# Service Bulletin

Bulletin No.: 25-NA-017

**Subject: Center Console Storage Door Difficult to Open and/or Binding or Stuck**

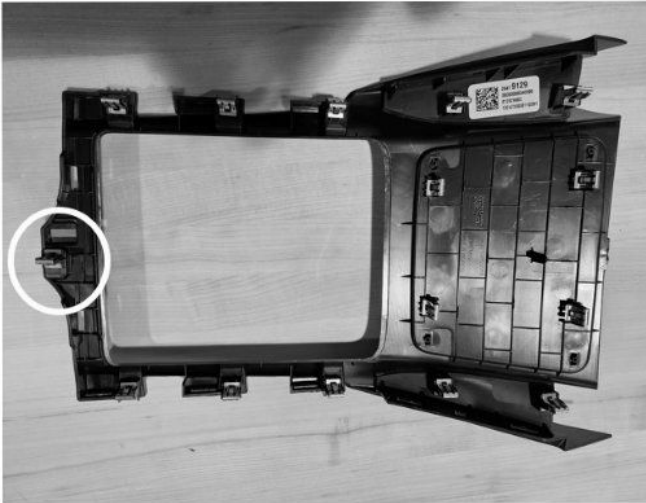
<b>Involved Region or Country</b>	United States, Canada, Mexico, Middle East, Israel, Palestine, Argentina (Mercosur), Brazil (Mercosur), Chile (West), Colombia (West), Ecuador (West), Uruguay (West)
<b>Condition</b>	Some customers my comment that the center console storage door is difficult to open, binding or stuck.
<b>Cause</b>	The floor compartment upper panel may be distorting and causing a bind condition.
<b>Correction</b>	Complete the procedure outlined below.

Remove the rib with suitable tool from the retention feature pictured above.

Reinstall and check for proper smooth operation.
